SERVICE BULLETIN

APPLICABILITY: 2017MY Impreza
 2015-17MY WRX and WRX STI

NUMBER: 06-65-18

SUBJECT: “Clicking” or “Ticking” Sound from VDC Hydraulic Control Unit

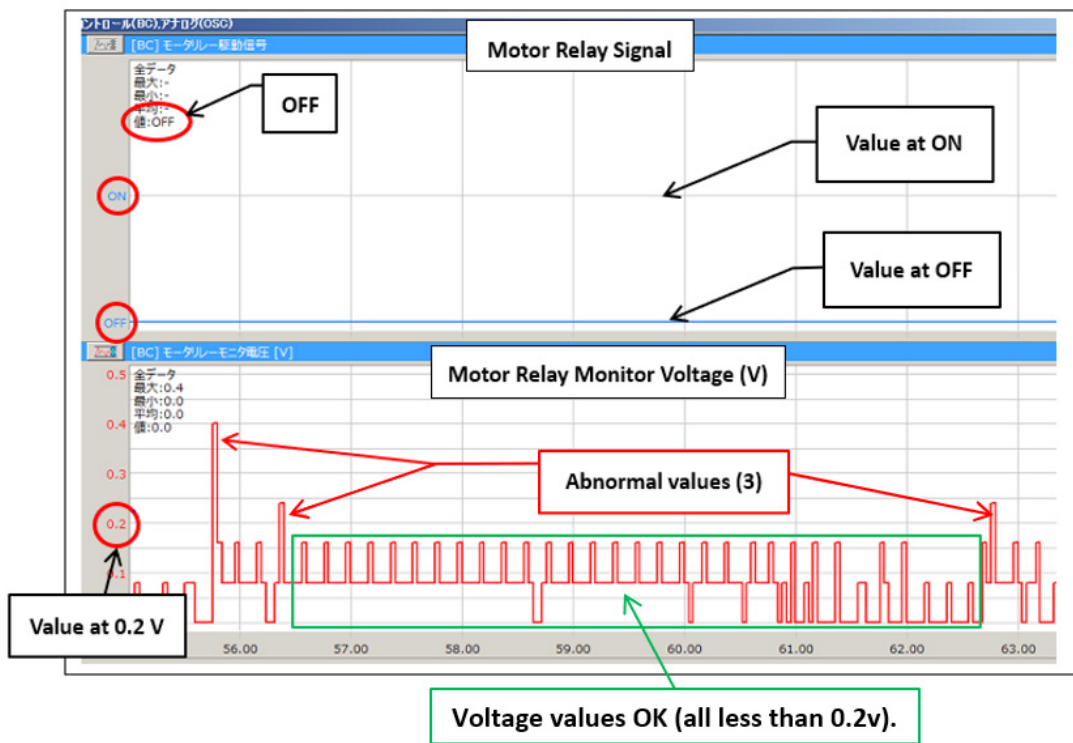
Step 2: Connect the SM4 and access data monitoring for the Brake Control system. Select the data for Motor Relay Signal and Motor Relay Monitor Voltage (V) as shown in the image below.

- **Scenario 2:** Inspect the value for Motor Relay Monitor Voltage. If any “spikes” of voltage exceeding 0.2v are identified while the Motor Relay Signal shows either ON or OFF, the VDCCM&HCU must be replaced.

Step 3: If either **Scenario 1** or **2** described above is confirmed, the VDCCM&HCU must be replaced.
